| <b>Project Title:</b>   | Puente Power Project   |
| <b>Document Title:</b>  | Report to Commission and Possible Commission Action Regarding the CEC's Application for Certification Review |

**RE:** Report to Commission and possible Commission action regarding the California Energy Commission’s Application for Certification (15-AFC-01) – NRG Energy Center Oxnard, LLC, Puente Power Project, reviewed pursuant to Coastal Act section 30413(d)

**Exhibit 9b**  
**15-AFC-01**  
**NRG Puente Power Project**  
**2016 Draft FEMA Flood Hazard Map**  
**Page 1 of 1**

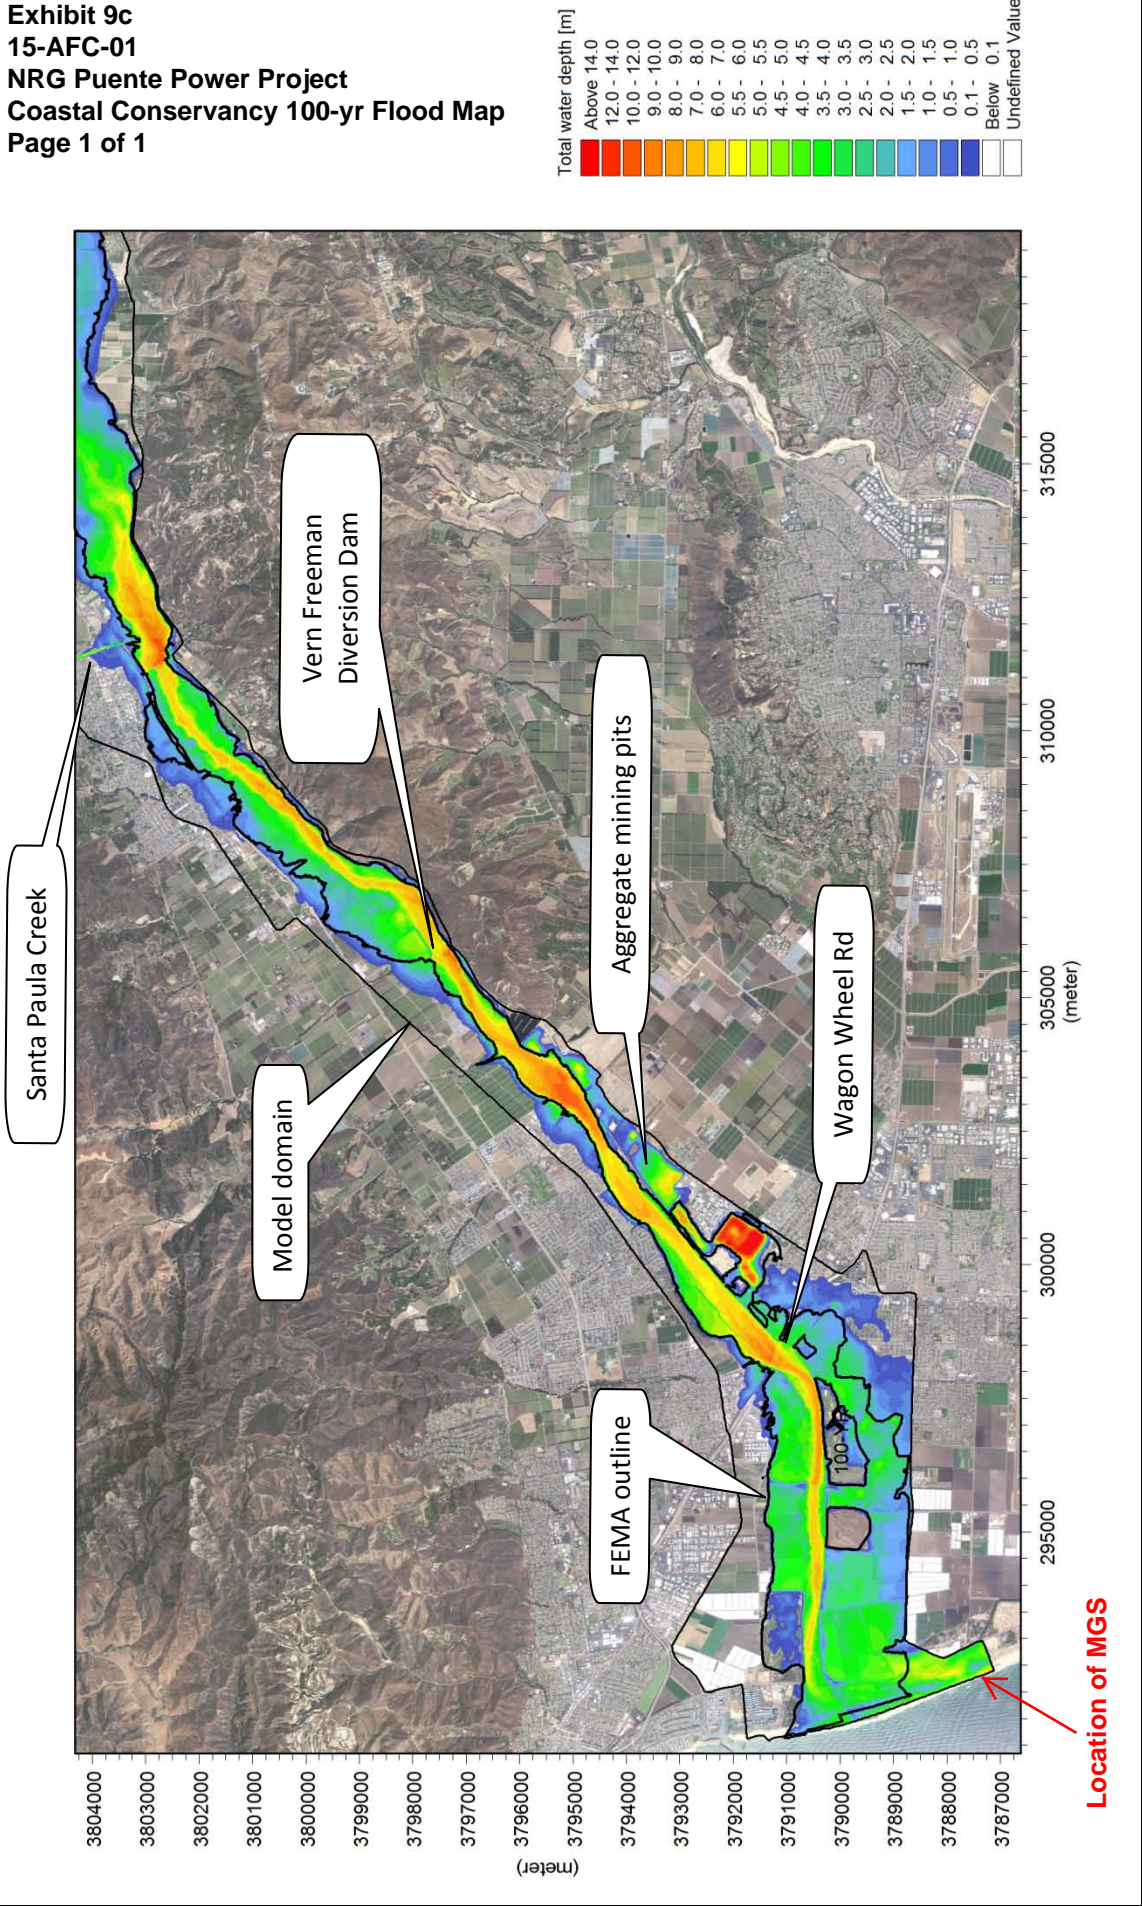
Commission staff notes that this projected maximum wave runup elevation with over 3 feet of sea level rise is lower than the *present-day* coastal base flood elevation (+20 feet NAVD88) shown on the 2016 draft FEMA flood map ([Exhibit 9b](#)). If two feet of sea level rise are added to the 2016 coastal base flood elevation, the 100-year flood zone in 2050 could reach +22 feet, which would almost certainly result in overtopping of the dunes and at least some flooding of the project site, even without accounting for erosion.<sup>16</sup>
